**RESPONSE TO MAY 31, 2019 USEPA CORRESPONDENCE
FORMER ROWE INDUSTRIES SUPERFUND SITE, SAG HARBOR, NEW YORK
NYSDEC SITE ID: 152106**

**WORK PLAN FOR *IN-SITU*
GROUNDWATER REMEDIATION**

**FORMER DRUM STORAGE AREA
ROWE INDUSTRIES SITE
SAG HARBOR, NEW YORK**

FIGURE
2

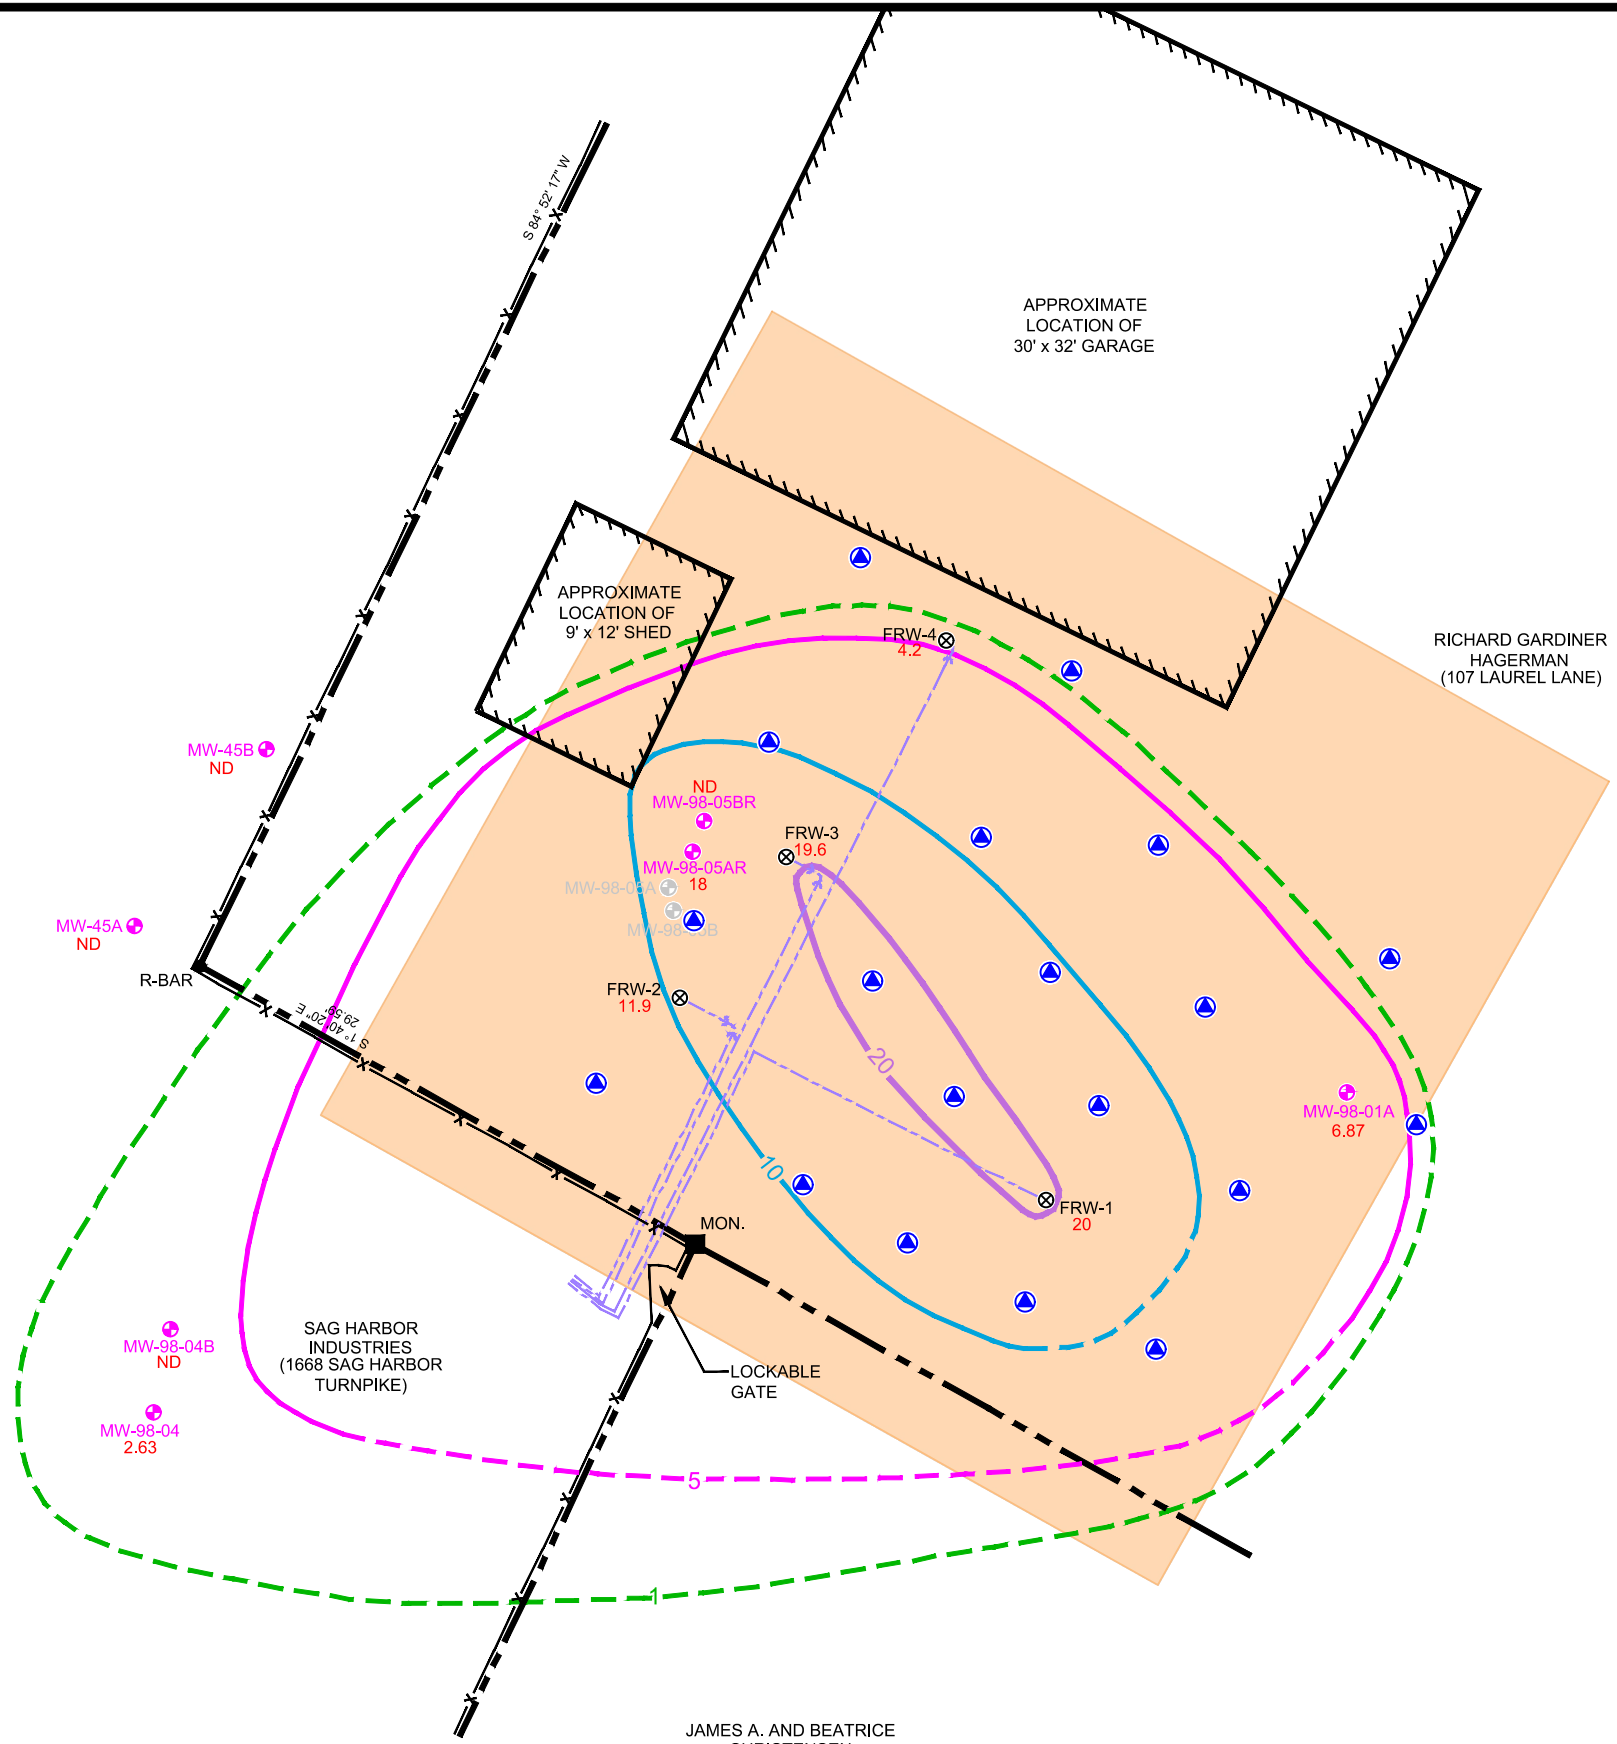
3. *Add an injection point in the area of the C3-2 and SB-13 soil boring locations.*

4. *No injection points should be located within a 10-foot radius of monitoring wells and/or focused recovery wells.*

An injection point has been added in the area of the C3-2 and SB-13 soil boring locations, and Figure 2 of the Work Plan has been updated accordingly.

Based on locations of site wells, it is not possible to maintain a 10-foot radius from all monitoring wells and/or focused recovery wells without adversely impacting subsurface distribution of amendment within the groundwater treatment zone. However, in response to this comment, the revised Figure 2 of the Work Plan provides increased distances between the wells and injection points when compared with the August 2019 Work Plan.
